# Access Compliance Report

## Public Rights-of-Way

### (Pedestrian Signals)

Intersection ID: N/A	Main Street:	Cross Street: N/A	Location: N/A
ADA ID: A8223883840B	Signal Type: One Push Button-Non APS	Overall Compliance: No	Severity Score: BTN 1: N/A BTN 2: N/A No BTN: N/A
Codes/Mitigation Info/Possible Solution		Field Measurements/Component Compliance

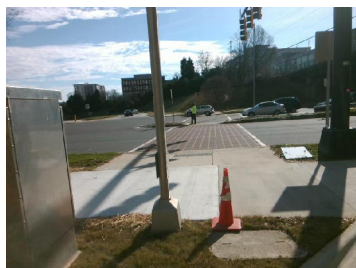
PROW/ADA: TMUTCD 4e.08, R406.2

Compliance	Description	Data	Compliance	Description	Data
	Button Count	Button1	N/A	Distant to Additional Button (in)	N/A
	Additional Button Present?	No		Additional Button ID	N/A
N/A	Signal Buttons Required?	N/A	N/A	Additional Ped Posts Required	N/A
	How Many Ped Street Xings?	1		Located In An Island/Median?	No
N/A	B 1 Sign Present?	Yes	N/A	B 2 Sign Present?	N/A
Yes	B 1 Sign Purpose?	Yes	N/A	B 2 Sign Purpose?	N/A
Yes	B 1 Sign Lettering & Contrast?	Yes	N/A	B 2 Sign Lettering & Contrast?	N/A
Yes	B 1 Parallel To XWalk?	Yes	N/A	B 2 Parallel To XWalk?	N/A
Yes	B 1 PAR to Button?	Yes	N/A	B 2 PAR to Button?	N/A
Yes	B 1 PAR to XWalk?	Yes	N/A	B 2 PAR to XWalk?	N/A
Yes	B 1 Clear Floor Space?	Yes	N/A	B 2 Clear Floor Space?	N/A
N/A	B 1 FWD Approach?	Yes	N/A	B 2 FWD Approach?	N/A
N/A	B 1 FWD Approach Constrained?	No	N/A	B 2 FWD Approach Constrained?	N/A
No	B 1 FWD Approach Reach (in)	3.0	N/A	B 2 FWD Approach Reach (in)	N/A

N/A	B 1 FWD Approach Width (in)	N/A	N/A	B 2 FWD Approach Width (in)	N/A
N/A	B 1 FWD Approach Obstruction?	Yes	N/A	B 2 FWD Approach Obstruction?	N/A
N/A	B 1 FWD Approach Obstruction Dist (in)	3.0	N/A	B 2 FWD Approach ObstructionDist (in)	N/A
N/A	B 1 PARA Approach?	Yes	N/A	B 2 PARA Approach?	N/A
N/A	B 1 PARA Approach Constrained?	No	N/A	B 2 PARA Approach Constrained?	N/A
Yes	B 1 PARA Approach Reach (in)	3.0	N/A	B 2 PARA Approach Reach (in)	N/A
N/A	B 1 PARA Approach Width (in)	N/A	N/A	B 2 PARA Approach Width (in)	N/A
N/A	B 1 PARA Approach Obstruction?	Yes	N/A	B 2 PARA Approach Obstruction?	N/A
N/A	B 1 PARA Approach Obstruction Dist (in)	3.0	N/A	B 2 PARA Approach ObstructionDist (in)	N/A
Yes	B 1 Clear Floor Space Slope (%)	1.1	N/A	B 2 Clear Floor Space Slope (%)	N/A
Yes	B 1 Clear Floor Space XSlope (%)	1.7	N/A	B 2 Clear Floor Space XSlope (%)	N/A
N/A	B 1 PAR Slope (%)	1.6	N/A	B 2 PAR Slope (%)	N/A
Yes	B 1 Height (in)	39.0	N/A	B 2 Height (in)	N/A

Yes	B 1 Clear Xing Direction?	ClearlyMarked	N/A	B 2 Clear Xing Direction?	N/A
	B 1 Crossing Direction	To SE		B 2 Crossing Direction	N/A
Yes	B 1 DistanceTo XWalk (in)	0.0	N/A	B 2 DistanceTo XWalk (in)	N/A
No	B 1 DistanceTo Curb (in)	234.0	N/A	B 2 DistanceTo Curb (in)	N/A
Yes	B 1 Diameter (in)	2.0	N/A	B 2 Diameter (in)	N/A

Possible Solutions: Replace Signal Push Button With APS Button on New Post. Remove & Relocate Sign.
